**REGULATION 4 OF THE INFRASTRUCTURE PLANNING (CHANGES TO, AND REVOCATION OF, DEVELOPMENT CONSENT ORDERS) REGULATIONS 2011
APPLICATION TO MAKE A NON-MATERIAL CHANGE TO THE OAKLANDS FARM
SOLAR PARK ORDER 2025 (SI 2025/739) AS CORRECTED BY THE OAKLANDS FARM
SOLAR PARK (CORRECTION) ORDER 2025 (SI 2025/1070)**

EN010122 – Oaklands Farm Solar Project Non-Material Change Application.

Interested Party Reference number: 20047649

nsip-documents.planninginspectorate.gov.uk/published-documents/EN010122-000819-EN010122 D7 6.1 ES Chp8 Appx 8.1 Flood Risk Assessment and Outline Drainage Strategy Clean.pdf

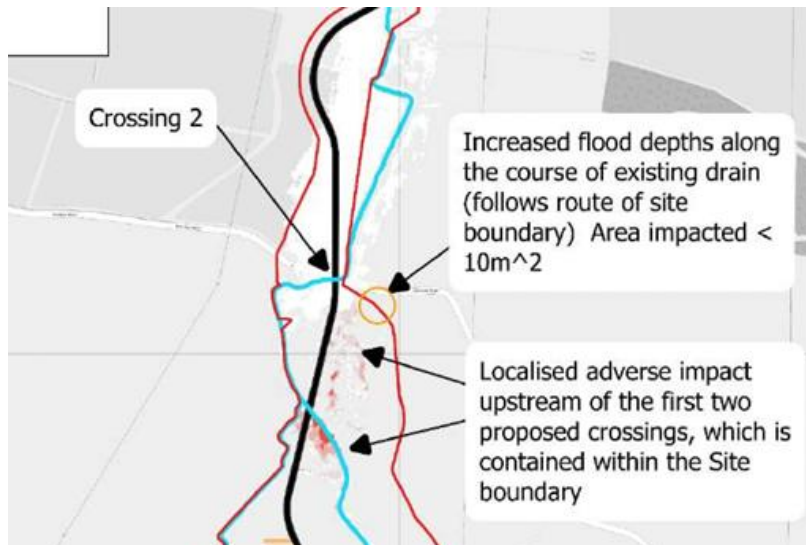
Please note for all these conditions it does not fulfil the requirements of the Development Consent Order (DCO) in that the submitted details do not “include the plans and strategies referred to in the flood risk assessment” as required by Requirement 17 part 2 of the DCO as they are not in accordance with the flood risk assessment which shows clearly land near Rosliston road may flood by up to 20cm. Please refer to FRA document dated Dec 2024.
